Columbia-Snake River Irrigators Association Policy-Technical Memorandum

SUBJECT: New Mercer Ranches Well Permit Should Be Issued Without Further Delay

SUBJECT: Management Instability Surrounding Issuing Mercer Well Permit G4-33245

MERCER RANCHES
APPLICATION FOR G4-33245
WATER AVAILABILITY REVIEW
February 18, 2026

Well Test Data

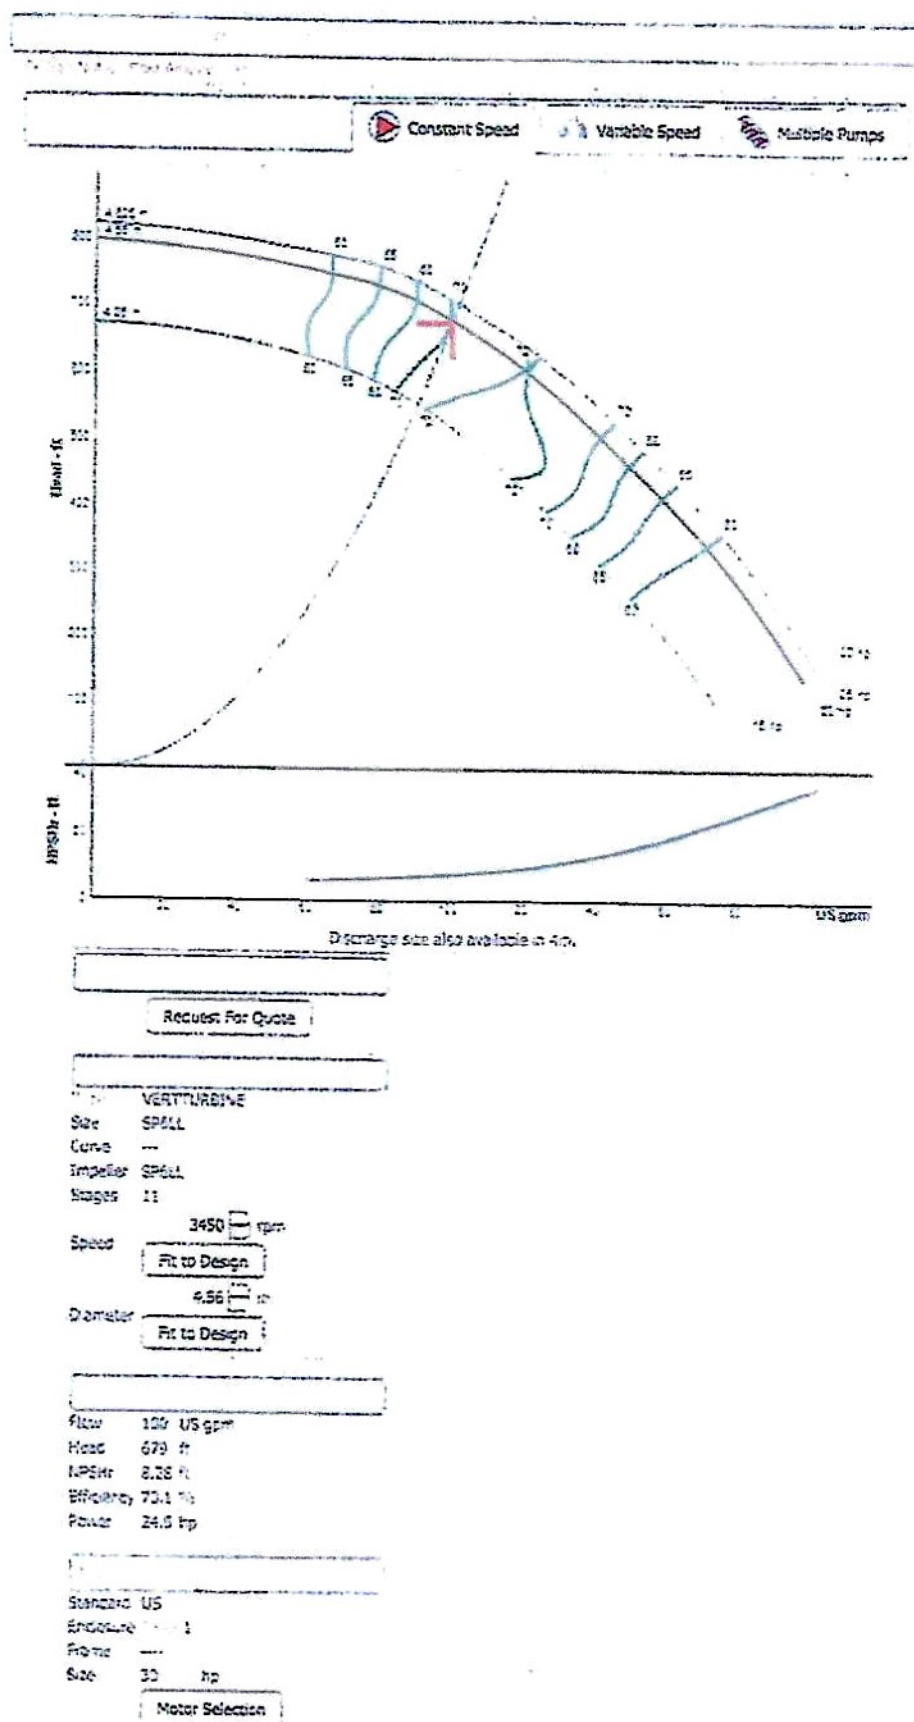
To further indicate that the aquifer yielding to the Spice Well matches or exceeds the values utilized for T and S in the above initial noted analysis, are the attached well test results. On August 26, 2020 Picatti Brother's Inc. tested the Spice Well for Mercer Ranches. The pump was started at approximately 10 AM and was

ramped up where the pump was pumping 100 gpm, by approximately 10:15 AM. The dynamic water level stabilized at 41' below the original static water level, shortly after reaching the 100 gpm flow rate. The flow remained at 100 gpm with a 41' dynamic drawdown below the original static water level, until the pump was shut off at 1:30 PM. During the 3 ½ hours of continuous pumping at 100 gpm, there was zero additional drawdown. Upon completion of the test the water level returned to the original static water level within the 2 minutes it took to take the measurement after shutting the pump off.

In a normal well test the dynamic water level declines with time, with the largest declines taking place early in the test. The fact that there was zero decline with time, indicates that the aquifer has a very high ability to transmit water. To further document this was the nearly instantaneous recovery after the pump was shut off. The cone of depression after pumping for 3 ½ hours appears to have been very small to recover this quickly. With the pump cycling off and on during normal operations, it is highly unlikely that any cone of depression associated with pumping the Spice Well will ever reach the Alexandria Nicole Cellars Well 1400 feet away.
